U.S. Patent Application No. 10/643,622
Attorney Docket No. 351913-992800 (2102397)

REMARKS/ARGUMENT

Fig. 1 Prior Art

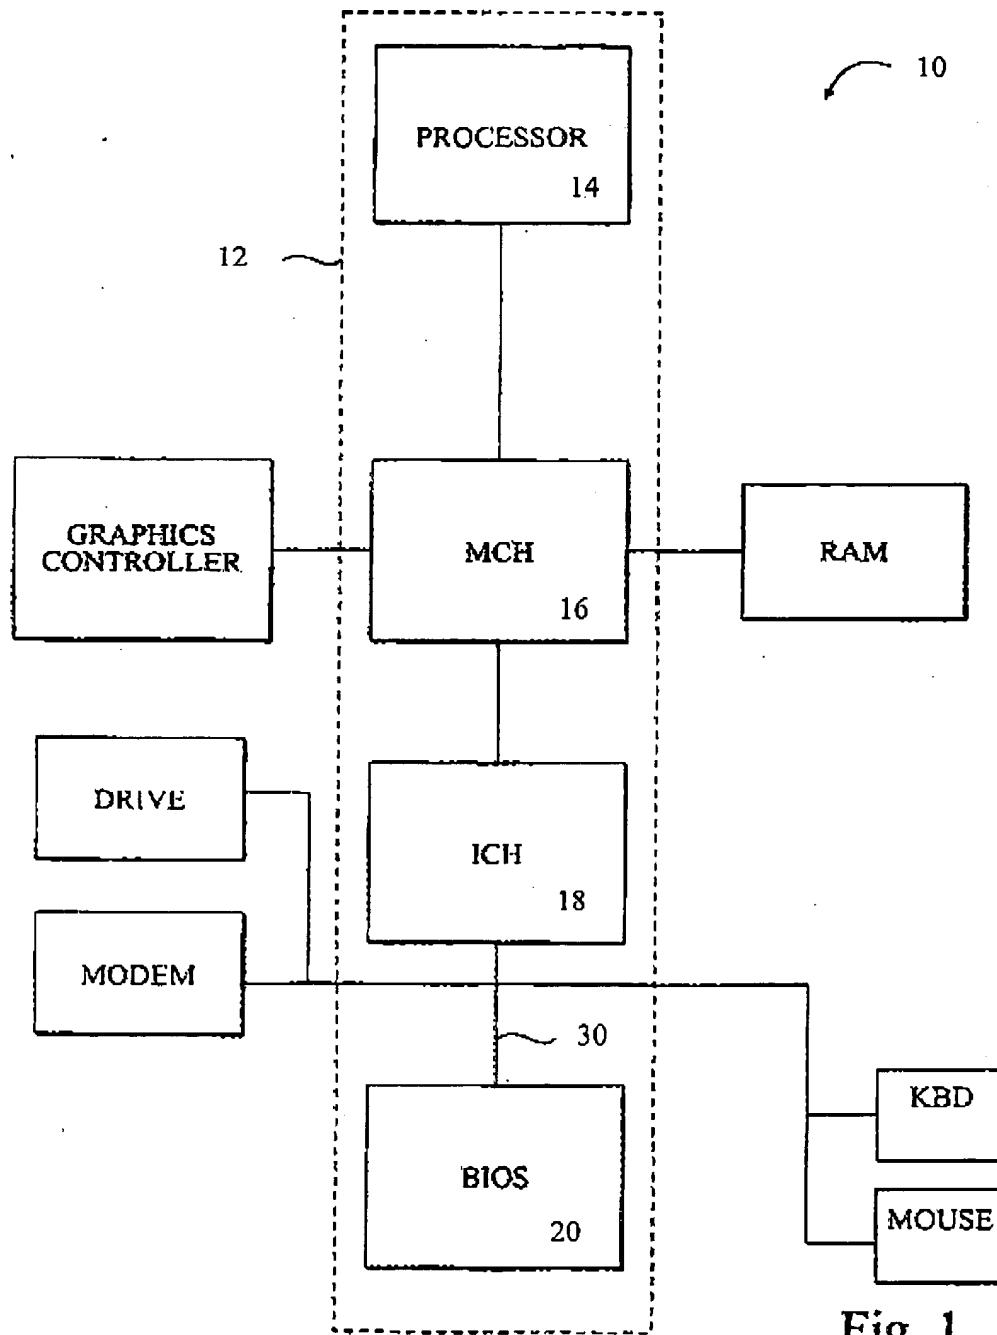
Figure 1 has been amended to comply with the examiner's request to label it by a legend – Prior Art- Replacement Sheet is attached.
